Amendments to the Drawings:

Remarks**I. Status of Claims:**

Docket No.: BFC-106-C1

FIG. 1

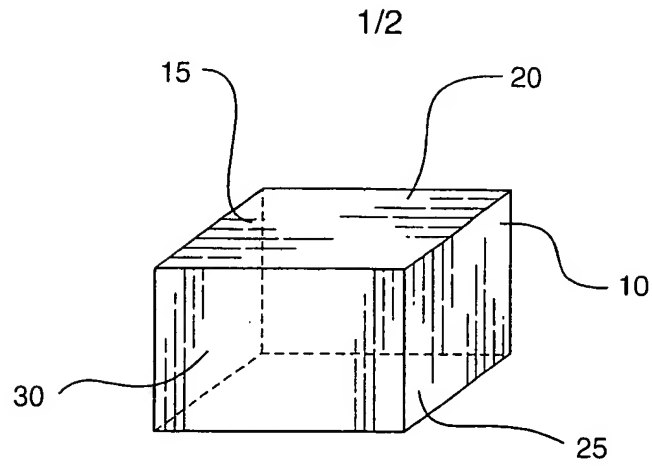
The drawings stand objected-to for the following reasons: reference characters "20" and "25" in Fig. 1, "47" in Figure 2 and "85" in Figure 4 are deemed not described in the specification. With respect to reference characters "20," "25" and "47," amendments to the specification have been made to describe the features highlighted by the reference characters. Support for the amendments is found in the drawings and throughout the specification.

FIG. 3

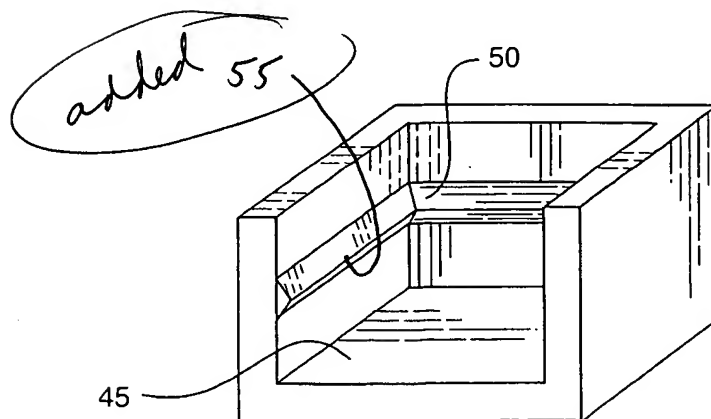
The attached sheets of drawings include changes to Figs. 3 and 4. These sheets, which include Figs. 1-6, replace the original sheets that include Figs. 1-6. In Fig. 3, previously omitted reference character 55 with an accompanying lead line has been added. In Fig. 4, reference character 85 has been changed to 55 to properly correspond with the description in the specification.

With respect to reference character "85," Figures 3 and 4 have been amended to change "85" to "55," which is the reference character that identifies the feature being described in the specification. Entry of the amended drawings is respectfully requested. The amendments to the specification and drawings render the objections to the drawings moot. Reconsideration and removal of the objections to the drawings are respectfully requested.
